Campaign Service BULLETIN

<p>BULLETIN NUMBER: CB07-E-001</p> <p>ISSUE DATE: OCTOBER 2007</p> <p>GROUP: BRAKES</p>

Incorrect Steering Gear Spacer Safety Recall 07V-469

2023366

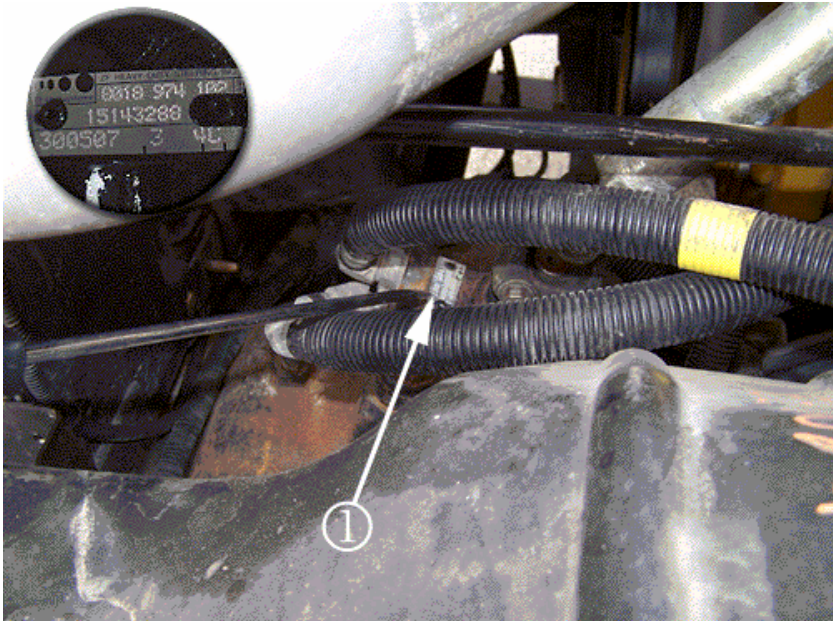
The steering gear information tab is located on top of the steering gear. The six-digit date code is located on the bottom of the steering gear tab. Refer to the illustration above. The view is from the left (driver's side) of the engine compartment.

- For steering gears with a date code beginning with 250407 (dd/mm/yy) and thereafter, the steering gear is good. No further action is required.
 - If the mileage on the vehicle is 15,000 miles or greater and the steering gear date code is prior to the vehicle build date, then the steering gear is good. No further action is required.
 - If the steering gear date code is after the vehicle build date, the steering gear is not original equipment. The steering gear requires replacement. Proceed to Step 2.
2. Replace the steering gear. Refer to *Steering Gear Replacement* in the service manual.
 3. Flush the power steering system. Refer to *Power Steering System Flushing* in the service manual.
 4. Bleed the power steering system. Refer to *Power Steering System Bleeding* in the service manual. Continue to APPLY CAMPAIGN LABEL.
